**CITY OF SAINT PAUL
HERITAGE PRESERVATION COMMISSION STAFF REPORT**

FILE NAME: 928 W. Seventh Street (historic address 415-419 Webster Street)
DATE OF APPLICATION: April 7, 2016
APPLICANT: Craig Cohen
OWNER: Schmidt Keg House, LLC, Craig Cohen
ARCHITECT: Studio M Architects, Inc., Chris Guerrero
DATE OF PRE-APPLICATION REVIEW: September 10, 2015
DATE OF PUBLIC HEARING: April 28, 2016
HPC SITE/DISTRICT: Jacob Schmidt Brewing Company Historic District
CATEGORY: Building Permit
CLASSIFICATION: Contributing
STAFF INVESTIGATION AND REPORT: Allison Suhan
DATE: April 22, 2016

1937 view from southeast, SBHD.A15

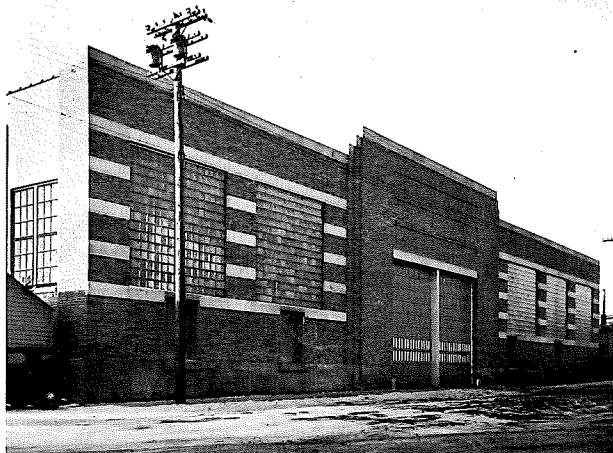
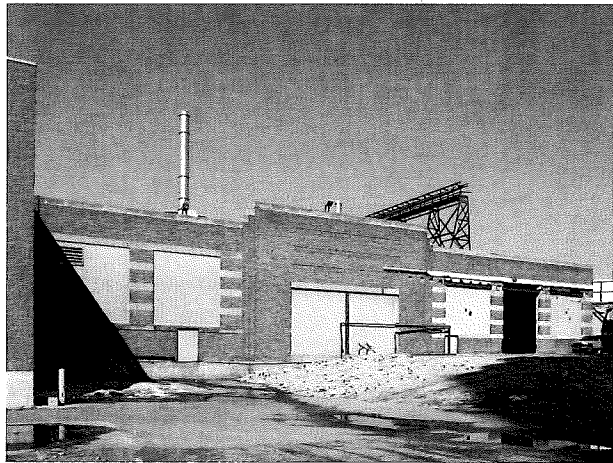
2. The south elevation windows shall replicate the historic vertical emphasis and divisions that are documented in the original drawings.
3. The applicant shall work with HPC staff and SHPO/NPS staff to revise the train doors to better reflect the character of the original doors. This could include the use of wood material to relate to the original doors and adjusting the solid to void ratio.

2. *East Train Doors:* Proposed replacement doors shall mimic the historic train doors, but may have man doors within them. The door and window assembly that is currently proposed does not sufficiently recall the historic door. Please revise the design and submit to SHPO and NPS for review and approval.
